## Development Permit Panel

1. **DEVELOPMENT VARIANCE 15-704583**  
(REDMS No. 5617123)

PROPERTY LOCATION: 10455 Bridgeport Road

**Re:** Application by Matilde Abella for a Development Variance Permit at  
10455 Bridgeport Road

PLAN #2

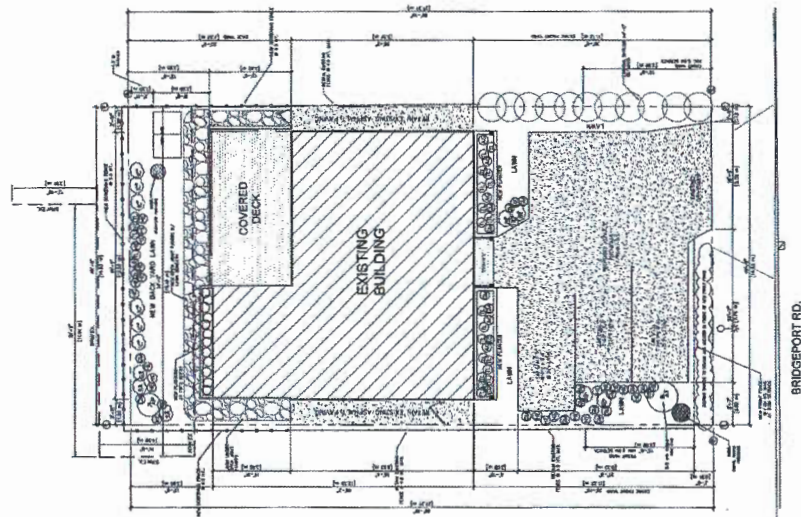
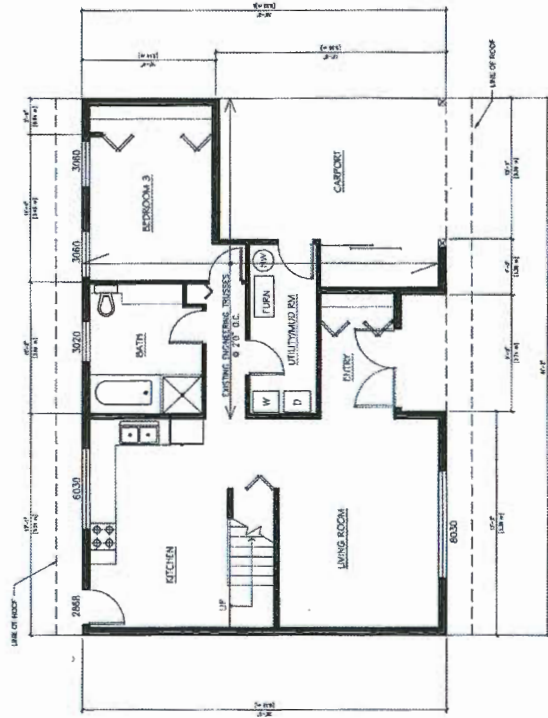
Panel Comment: *explore the possibility of reducing the amount of paved area in the front yard and investigate further opportunities for increasing the landscaped area in the subject site.*

- *The applicant has proposed to increase the amount of live landscaping coverage in the required front yard setback from 29% (26.5 m<sup>2</sup> (285 ft<sup>2</sup>)) to 36% (32.6 m<sup>2</sup> (351 ft<sup>2</sup>)).*

- *The width of the landscape strip adjacent to Bridgeport Road has also increased from 0.9 m (3 ft.) to approximately 2.4 m (8 ft.), providing a greater buffer between the vehicle parking area and the street.*

- *The revised proposal provides an increase in landscaped area in the required front yard setback from the original proposal by shifting the vehicle parking stalls north. This results in a greater percentage of landscaping in the front yard, and maintains 30% live landscaping coverage for the entire lot, consistent with Zoning Bylaw requirements.*

DRAWING DESCRIPTION:  
LANDSCAPE &  
PLANTING PLAN

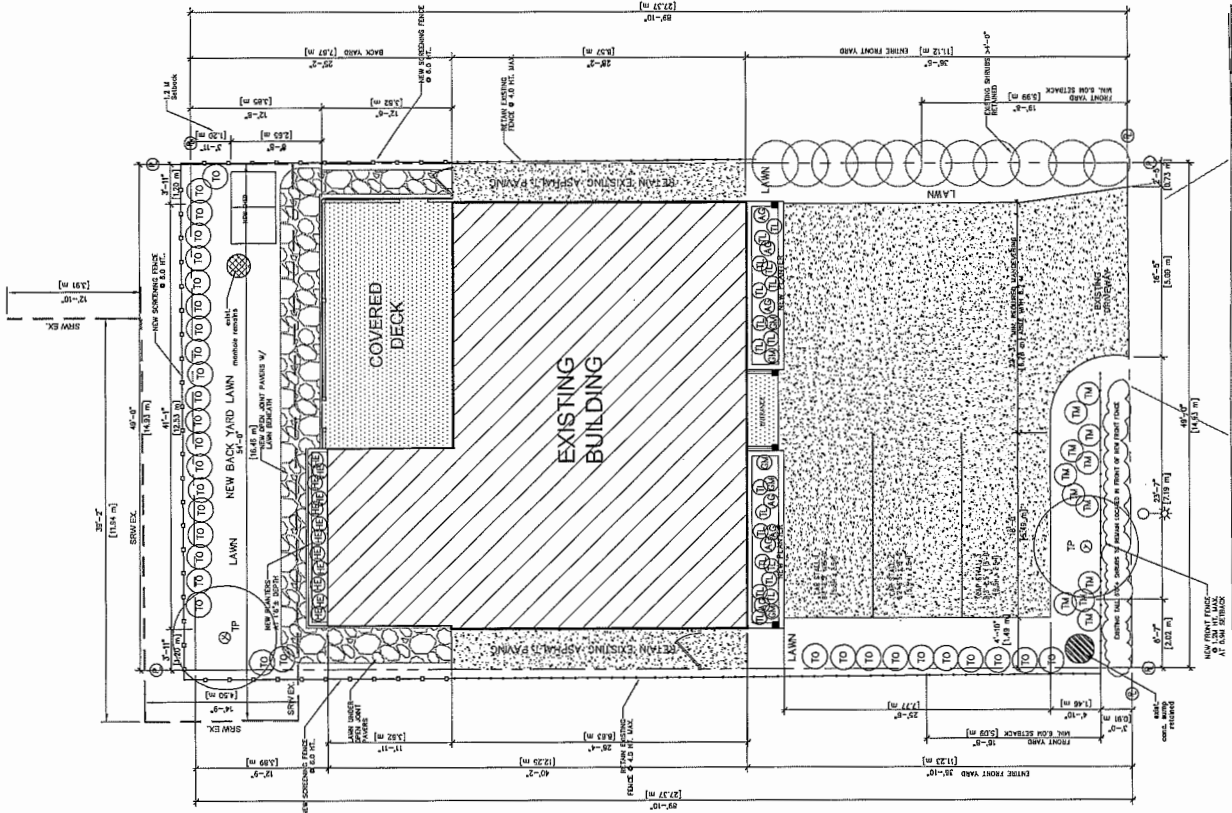
Panel Comment: *review the proposed planting plan with a view to increasing the size of trees and shrubs to enhance the overall on-site landscaping and provide adequate screening of the existing non-conforming house addition from adjacent properties.*

- *The revised Landscape Plan has increased the size of trees and shrubs to enhance the landscaping and provide additional screening of the rear addition and vehicle parking area.*

- *Upon recommendation from the City's Tree Preservation staff, the following tree and shrub species have been added to the Landscape Plan: Western Red Cedar, Pyramid Cedar and Hick's Yew. These species were identified as effective for screening purposes.*

- *The proposed trees have changed from a deciduous tree (6 cm dbh) and a coniferous tree (3.0 m in height) to two coniferous trees (3.5 m in height). The proposed size exceeds the City's replacement tree planting height requirements and the proposed species will provide screening all year round.*

- *The number of proposed shrubs has significantly increased, from 13 in the original proposal to over 50 in the revised proposal. The proposed species of shrubs are also greater in height compared to the species originally proposed.*

- *Landscaping areas have been redesigned to provide improved screening of the rear yard addition and front yard parking area, in addition to the proposed new 1.2 m high fence along a portion of the front yard and a new 1.8 m high fence along the rear yard.*
